Assessment report to Sydney Central City Planning Panel

2017SWC127

DA number	SPP-17-00034	Date of lodgement	13 October 2017
Applicant	Department of Education C/- Urbis Pty Ltd		
Owner	Crown		
Proposed development	Construction of a new 2 storey school building at Riverbank Public School, minor internal refurbishment, removal of car parking and tree removal		
Street address	Lot 11 DP 1200915, 25 Wentworth Street, The Ponds		
Notification period	14 to 28 November 2017	Number of submissions	0

Refer to Drawing No.
AR-SK-DMT.001 (Rev
B) dated 17 September
2018 for parking layout

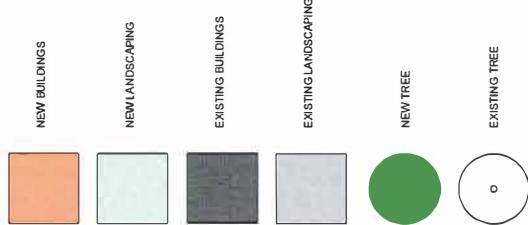
7.2.6 The applicant has now submitted an amended site plan showing alternative locations for the displaced car parking spaces. Furthermore, the plan also shows the 10 additional parking spaces required under the DCP to cater for the new development. Now the required 165 car parking spaces can be provided on site.
